**ADDENDUM No. 1**

**CONTRACT NO. B436**

**PLANTWIDE SUPERVISORY CONTROL AND DATA ACQUISITION (SCADA)  
SYSTEM IMPROVEMENTS PROGRAM – WET TRAIN/LINE OPERATIONS**

**July 7, 2026**

| DRAWING NUMBER: | E-801     |

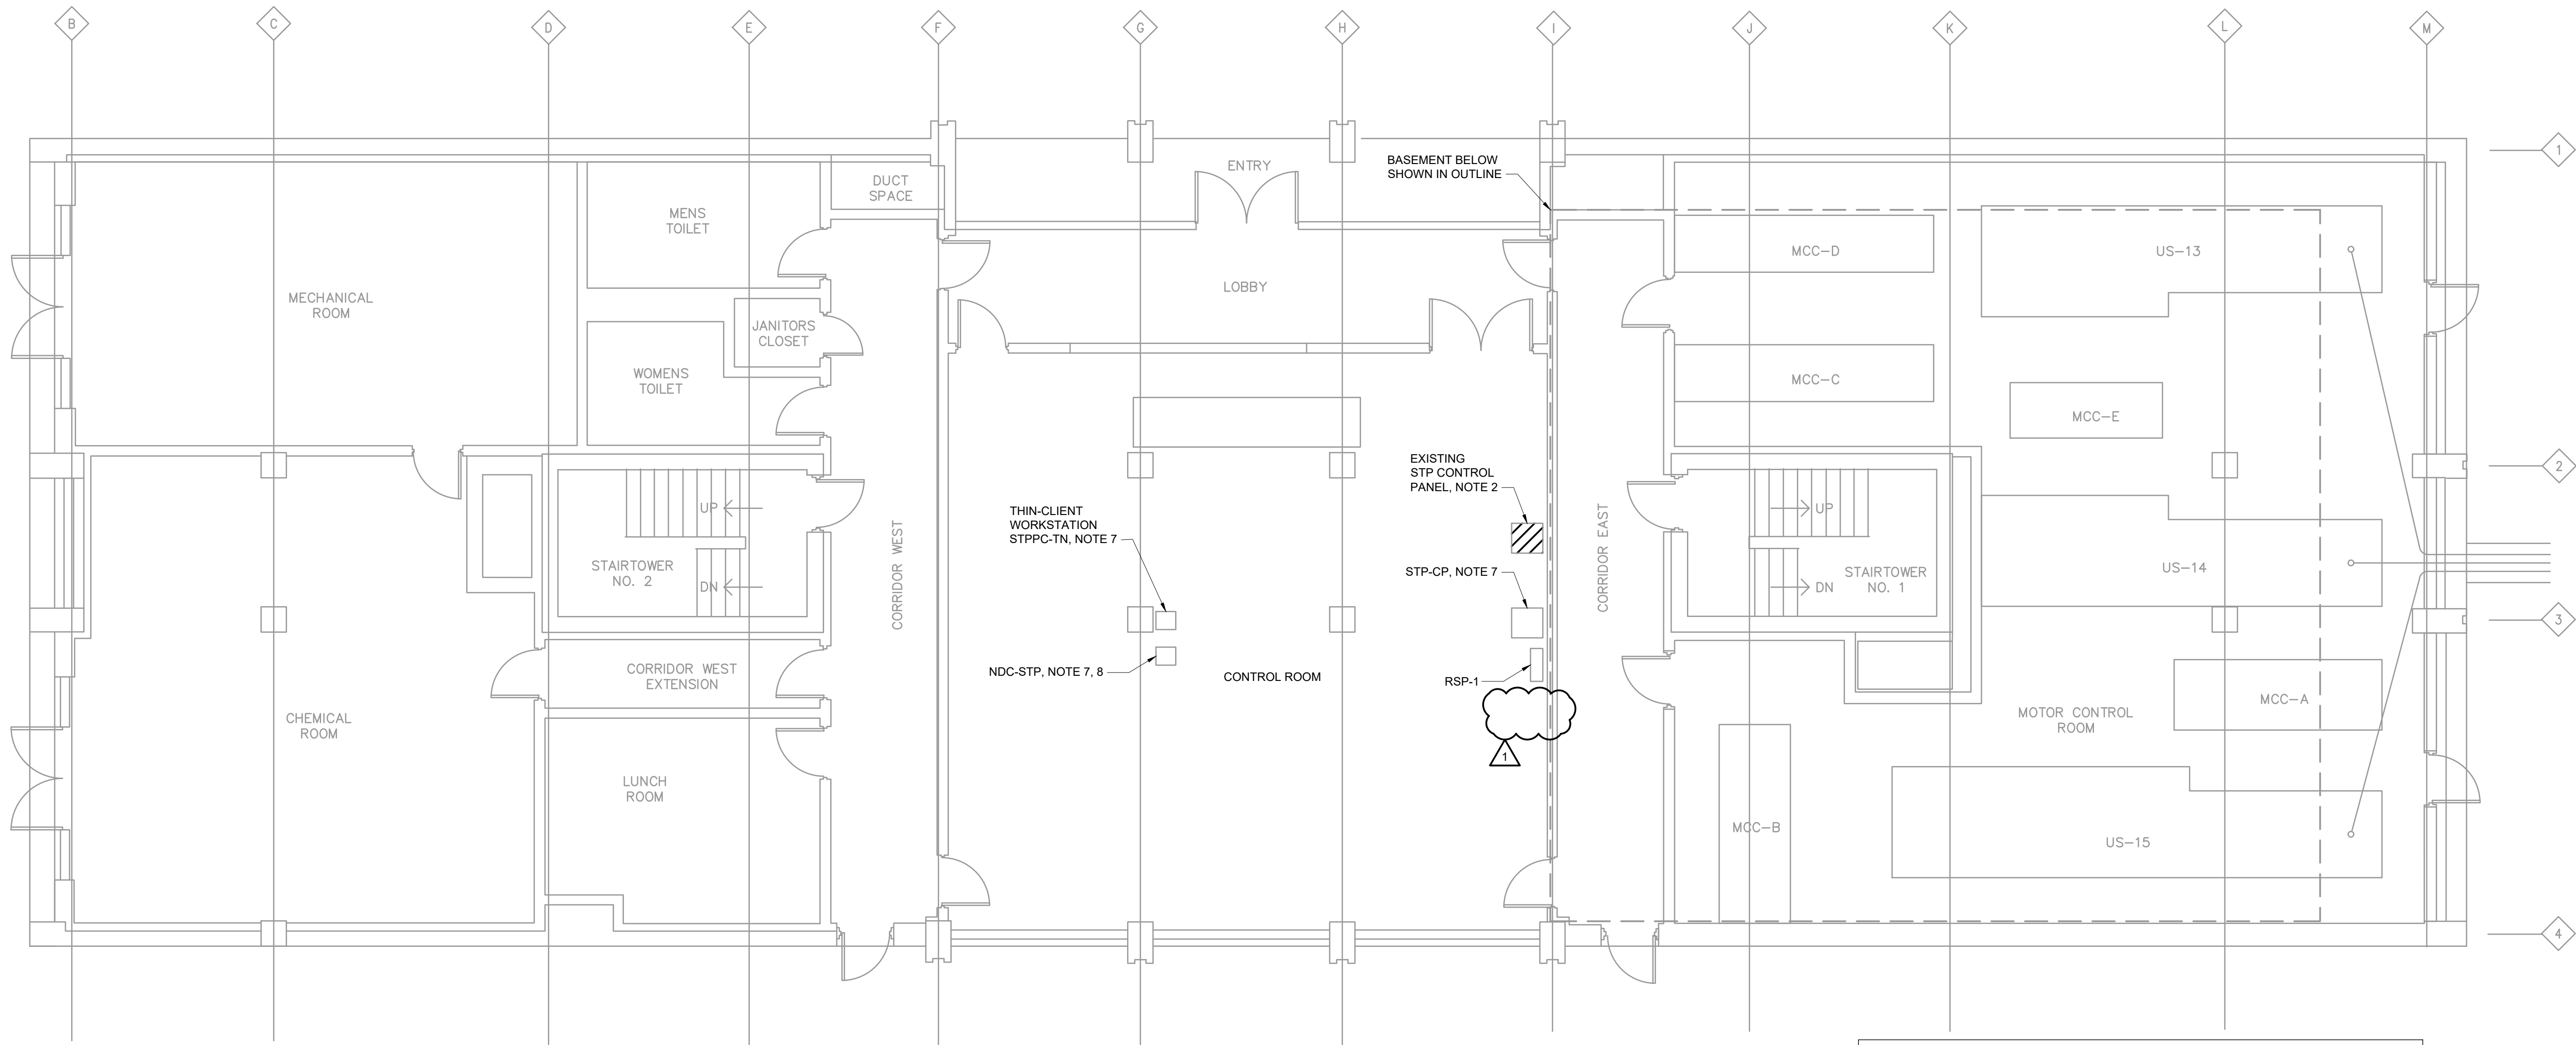
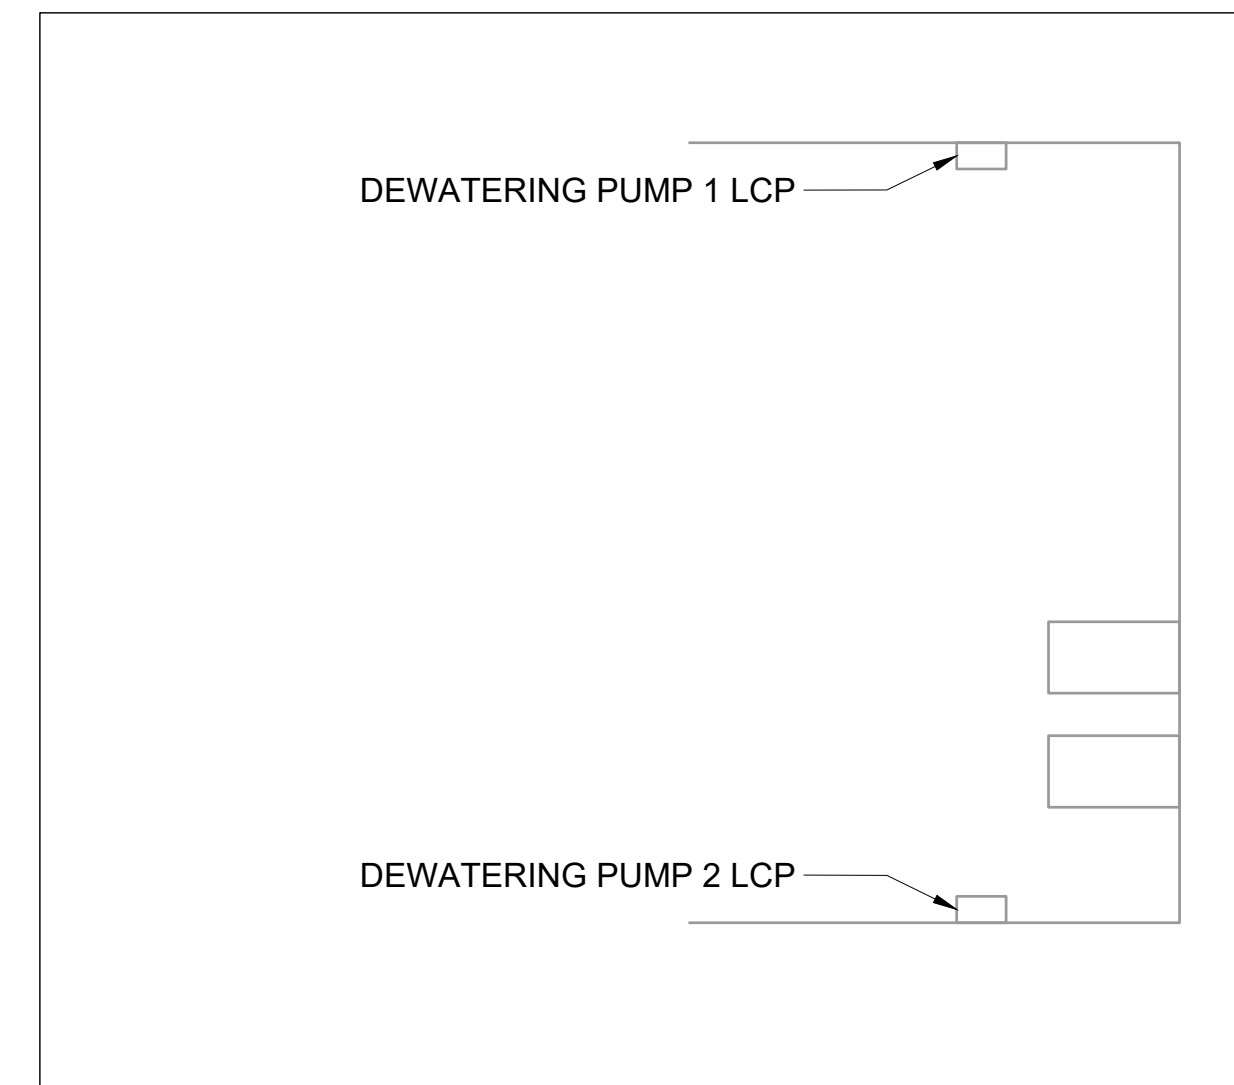
- h. E-601 – Electrical Effluent Pump Station Second Floor Plan
  - i. E-801 – Electrical Supernatant Treatment Plant Process Control Building Plan
4. See attached copy of the slides presented at the non-mandatory Pre-Bid Meeting, held on June 29<sup>th</sup>, 2026 at PVSC, which are provided for bidder information only and are expressly excluded from this contract.
